Pollard Street

Section 73 Addendum to Accompany
Design and Access Statement

December 2023

Hawkins\Brown

7.4 Typical Upper Floor Plan

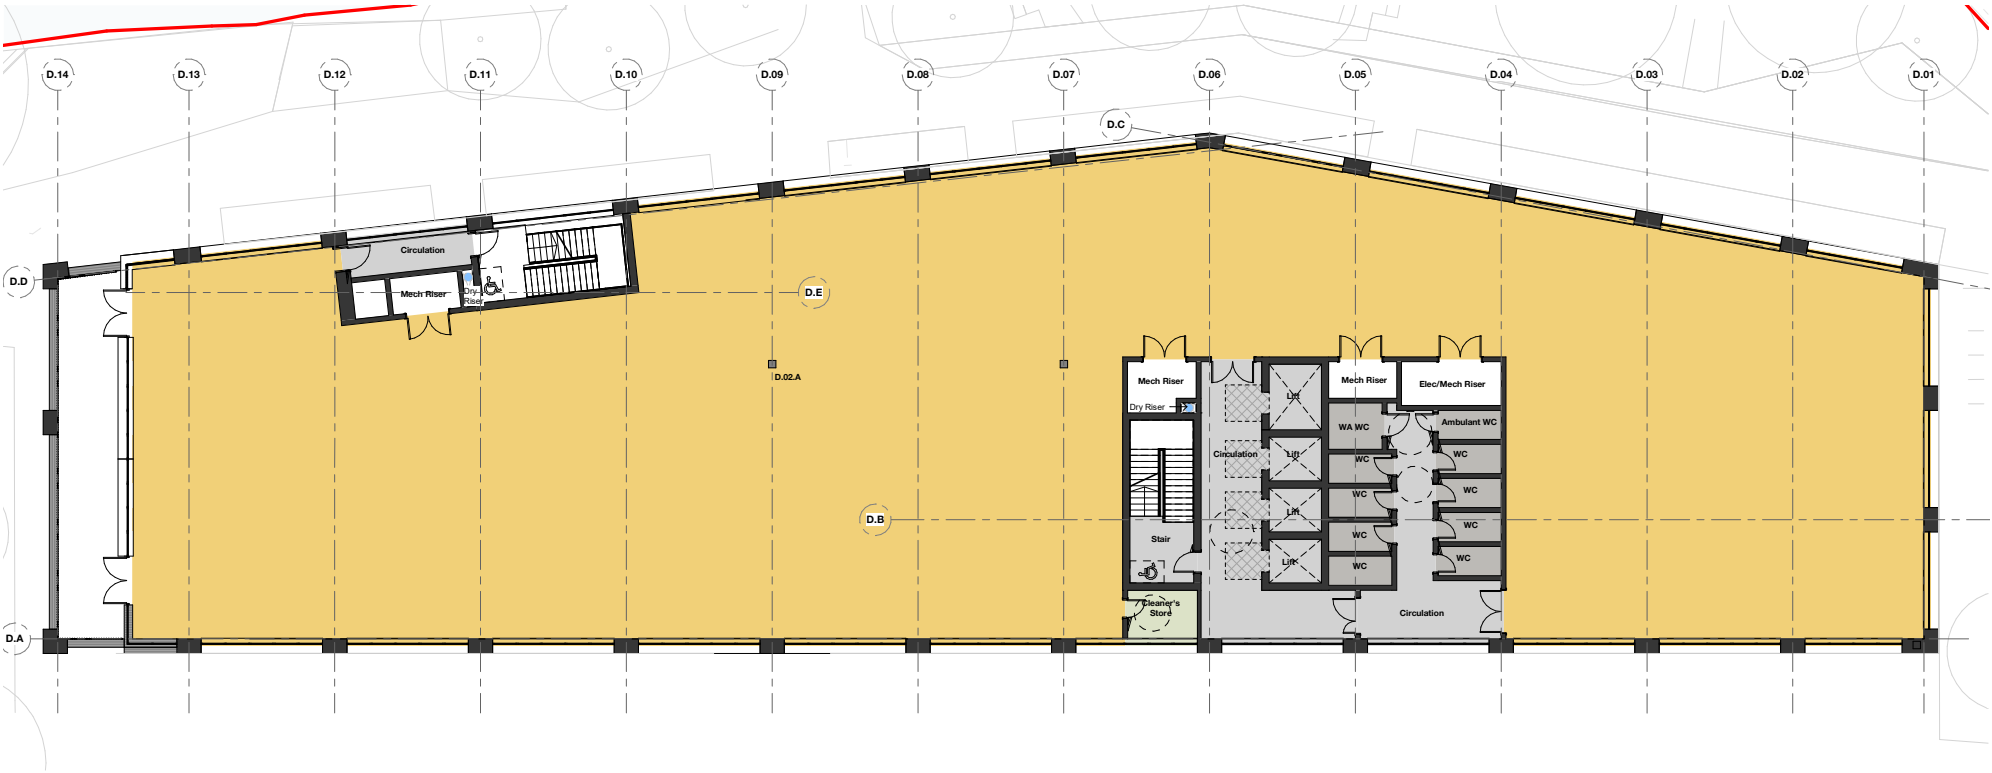
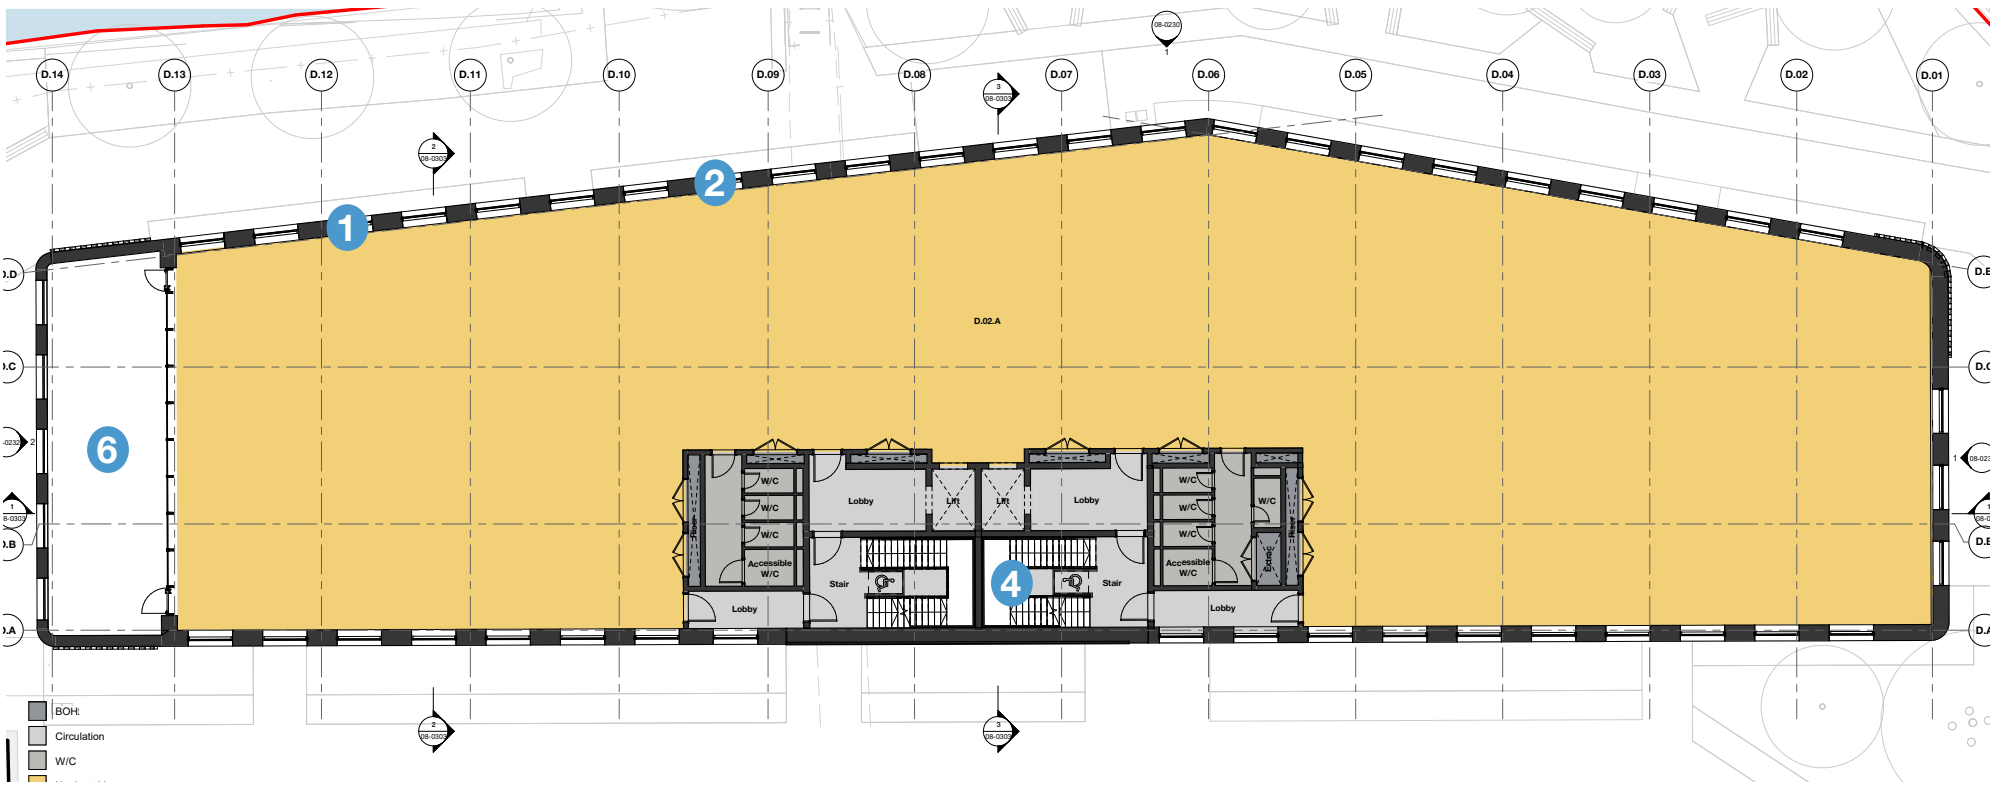
1. Primary façade cladding changed from metalwork to brickwork
2. Window arrangement updated
3. Ground floor access relocated
4. Second stair relocated within the central core
5. Internal layout updated
6. External gantry replaced with external terrace
7. Roof terrace relocated
8. Position of plant screen updated
9. Roof access updated

7.5 Roof Plan

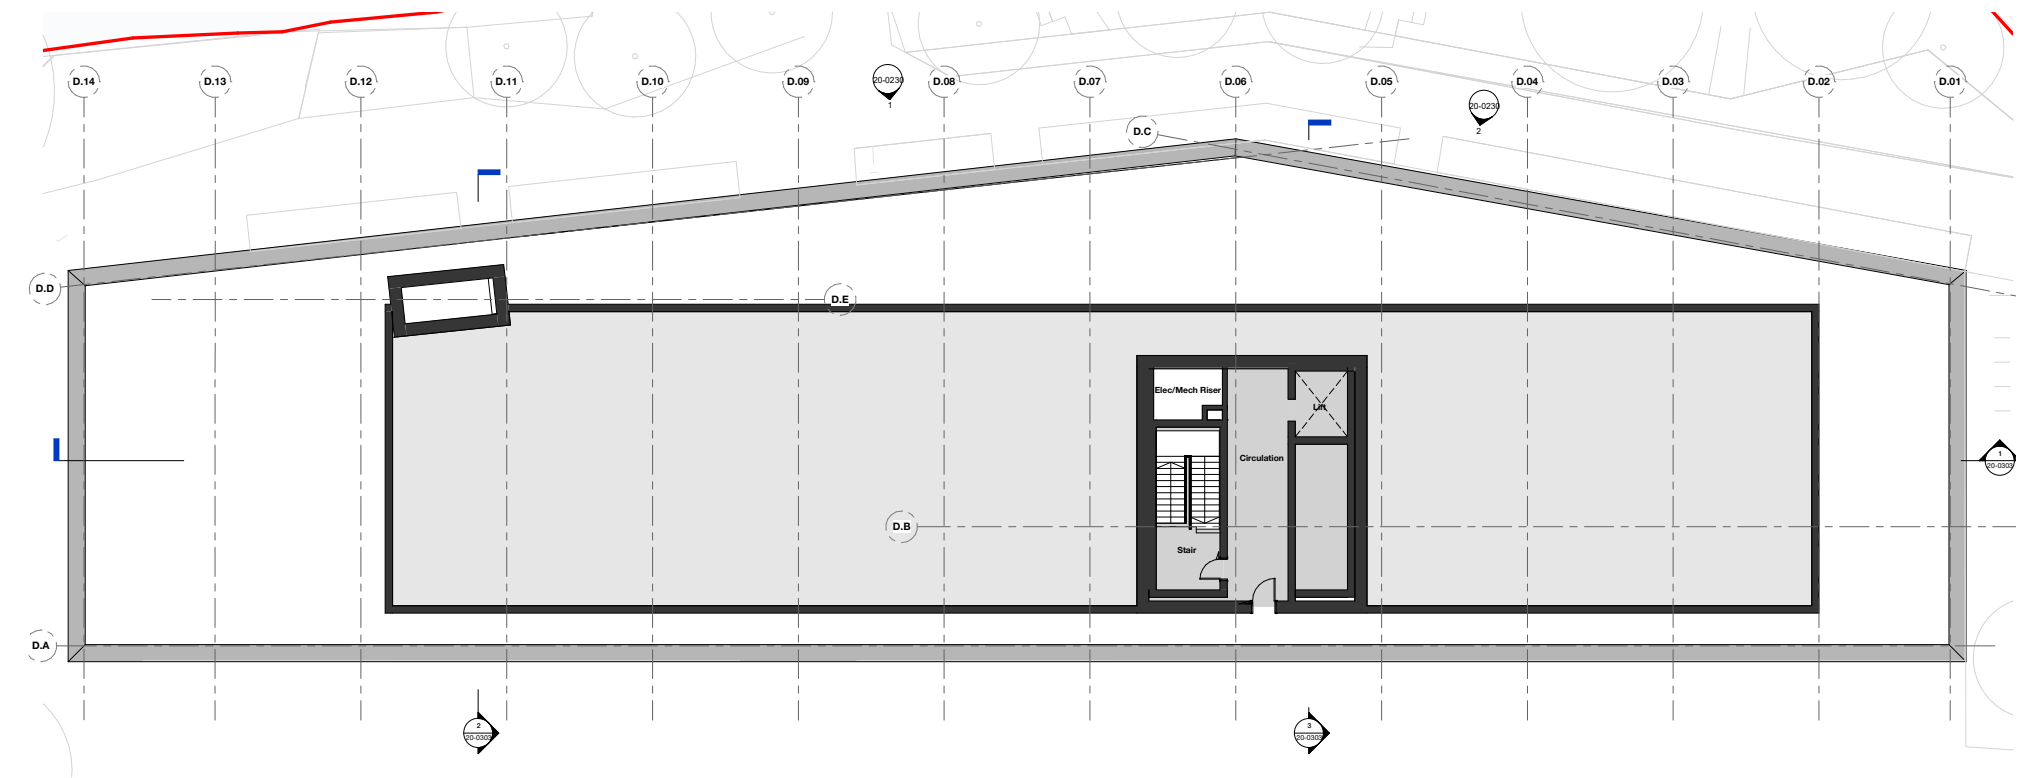
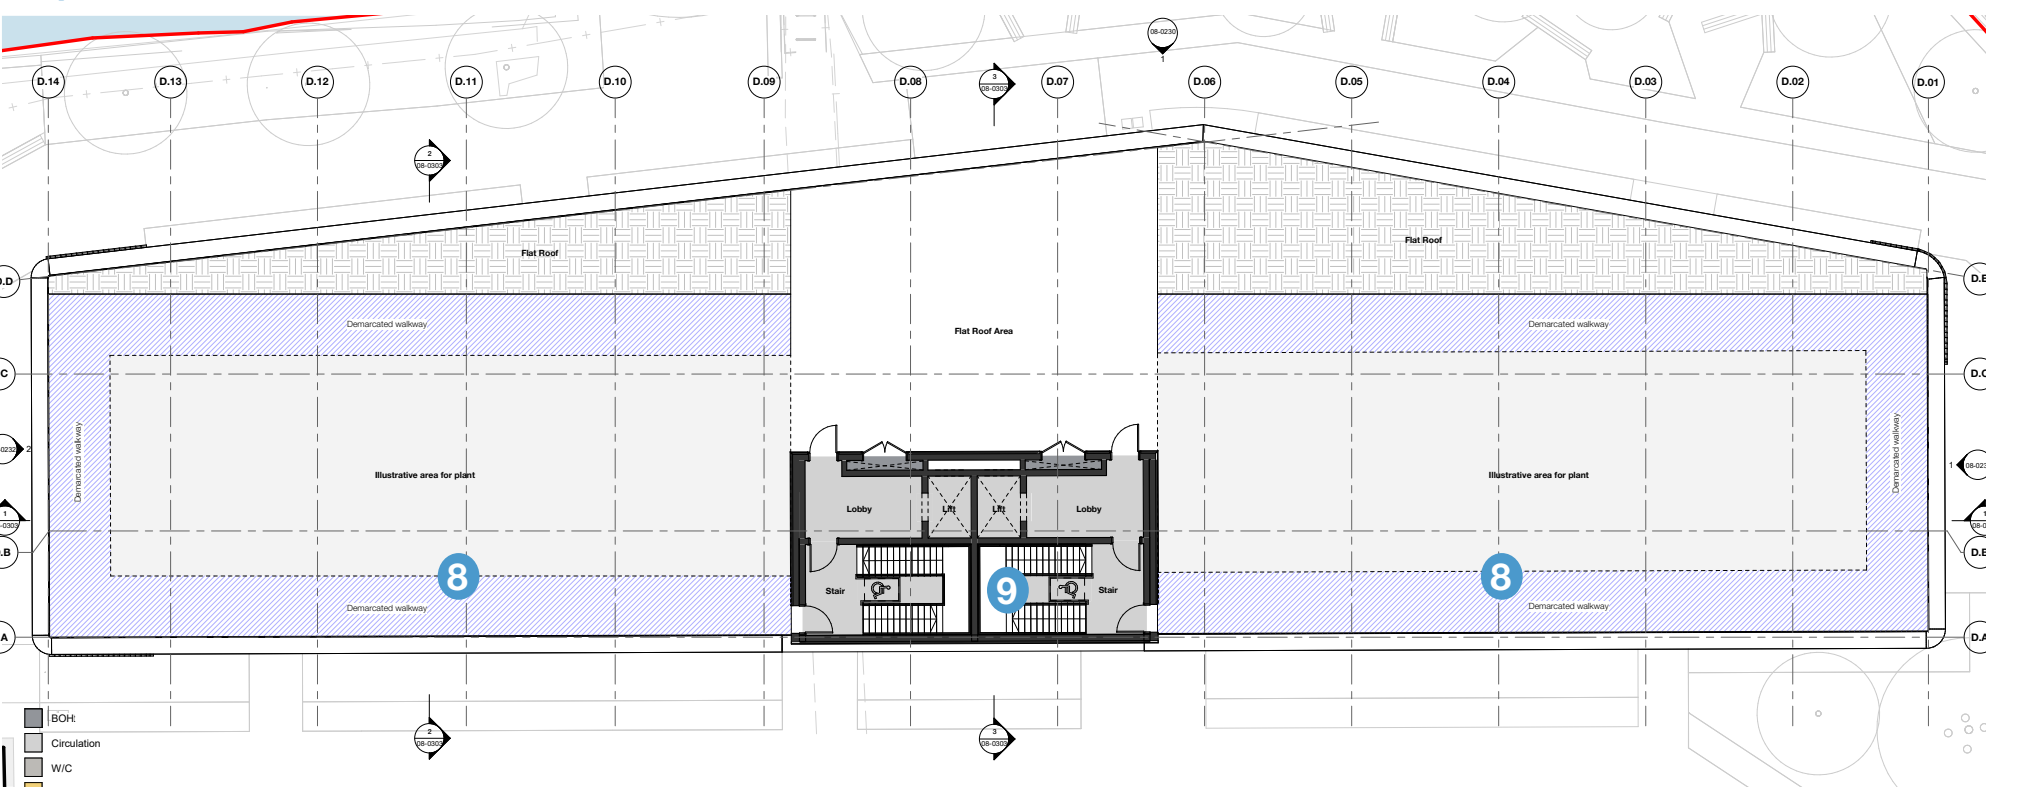
- 1. Primary façade cladding changed from metalwork to brickwork
- 2. Window arrangement updated
- 3. Ground floor access relocated
- 4. Second stair relocated within the central core
- 5. Internal layout updated
- 6. External gantry replaced with external terrace
- 7. Roof terrace relocated
- 8. Position of plant screen updated
- 9. Roof access updated

First Floor Plan

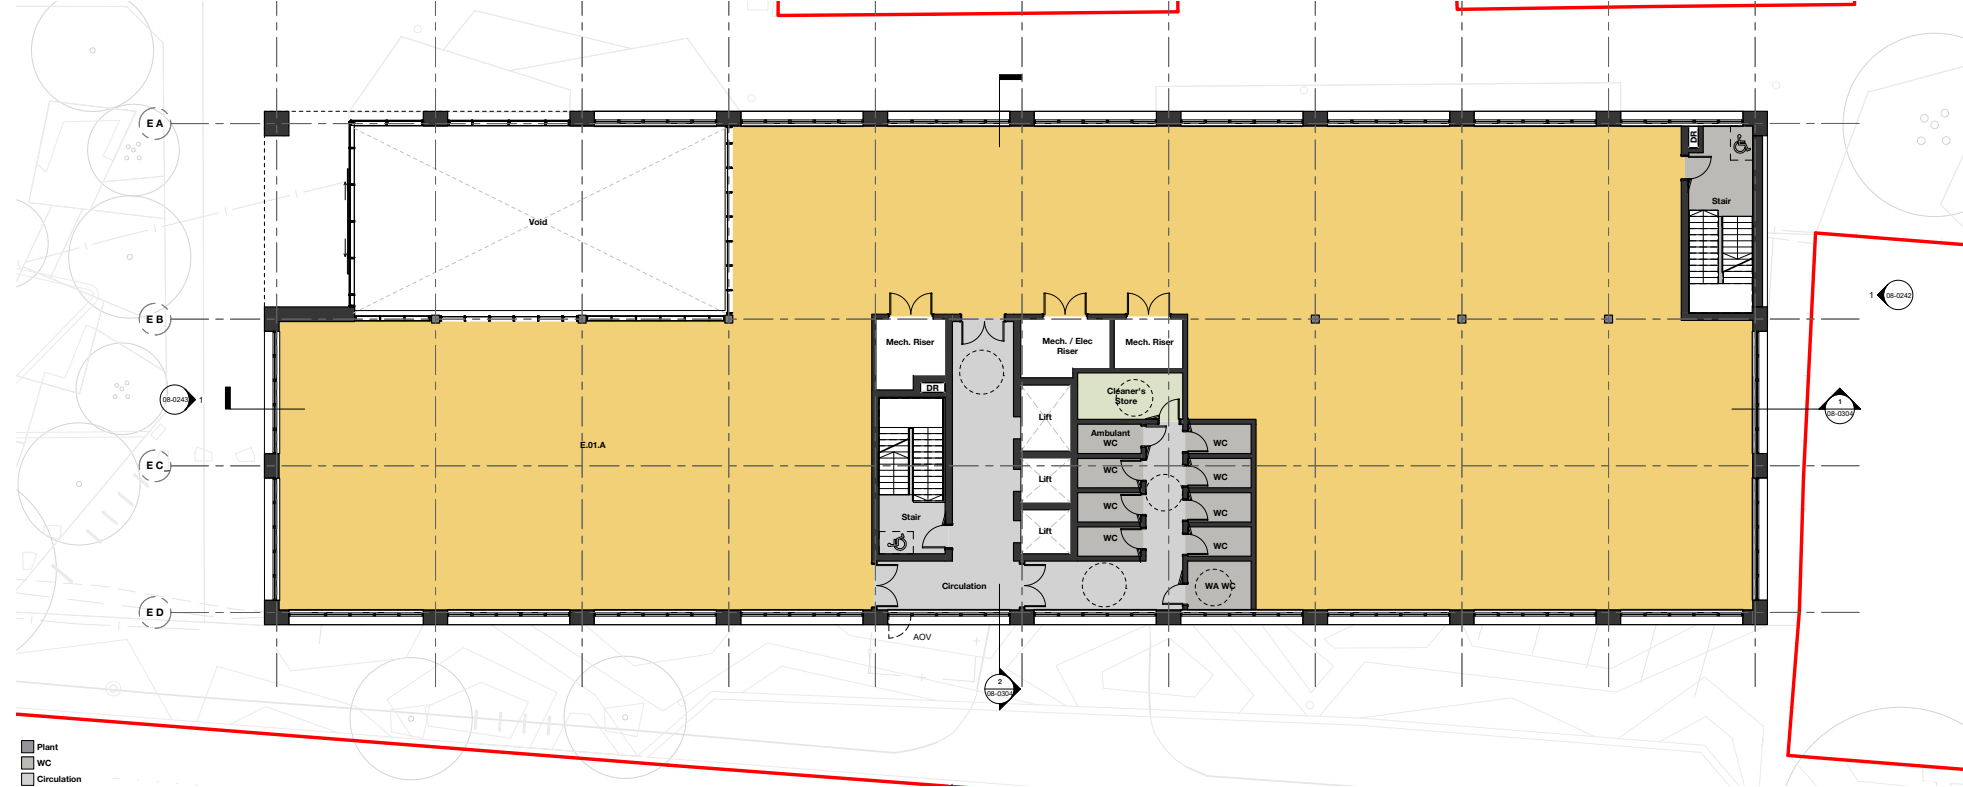
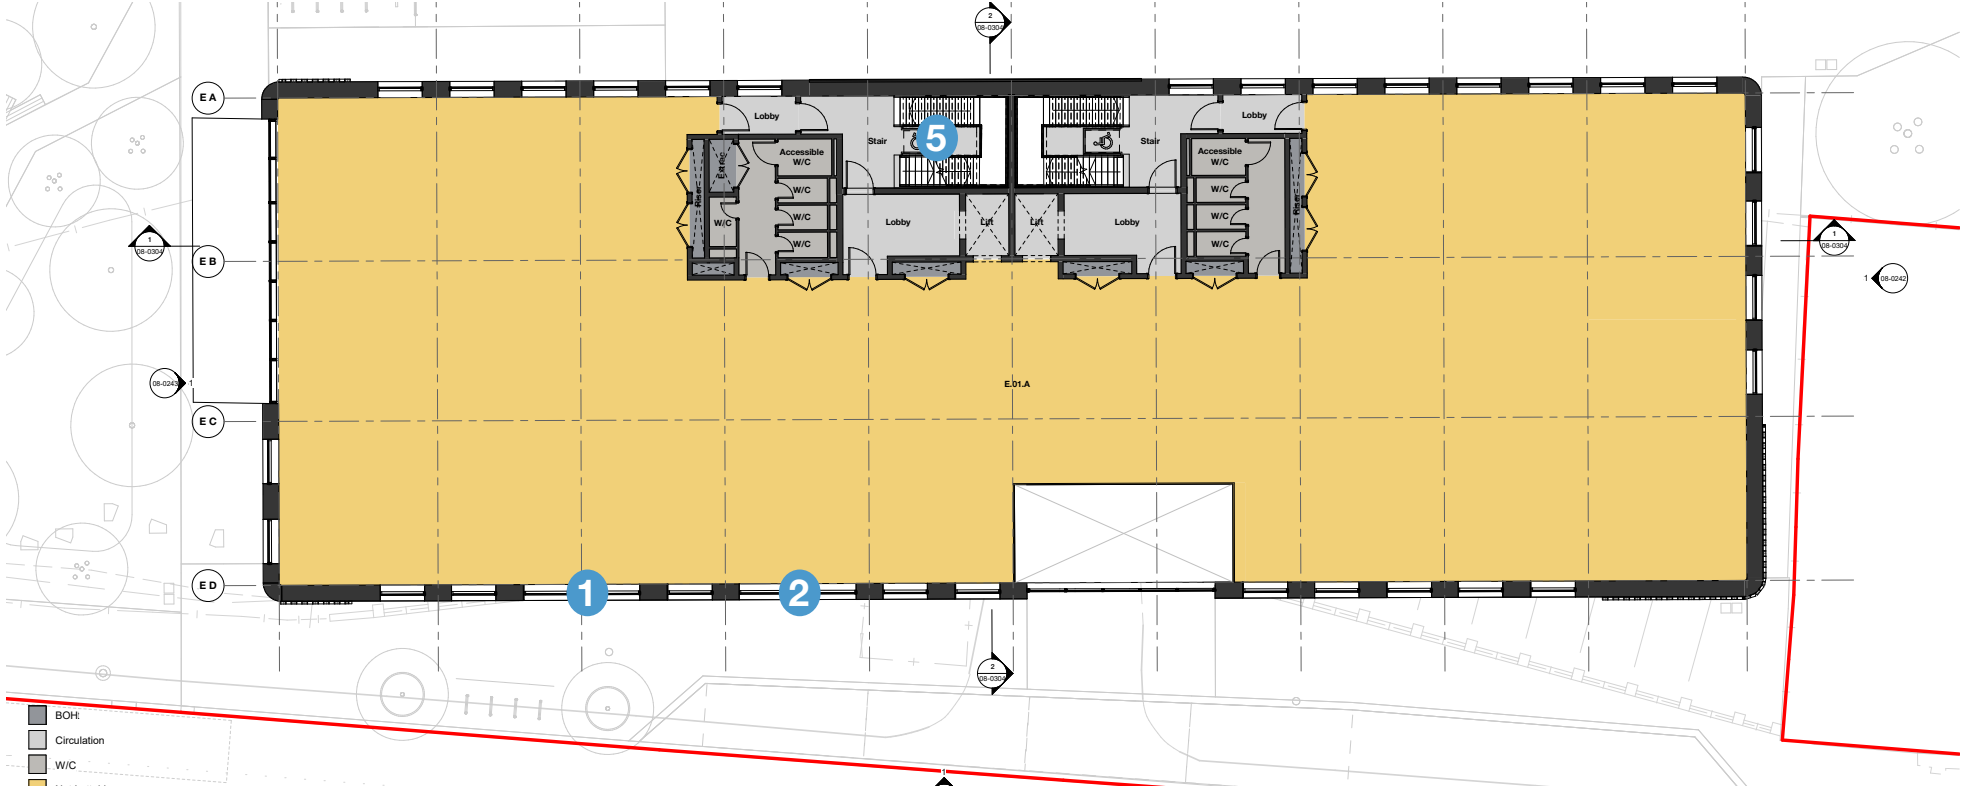
- 1. Primary façade cladding changed from metalwork to brickwork
- 2. Window arrangement updated
- 3. Main workspace entrance relocated
- 4. Ground floor access relocated
- 5. Second stair relocated within the central core
- 6. Internal layout updated
- 7. External gantry replaced with external terrace
- 8. Roof terrace relocated
- 9. Position of plant screen updated
- 10. Roof access updated
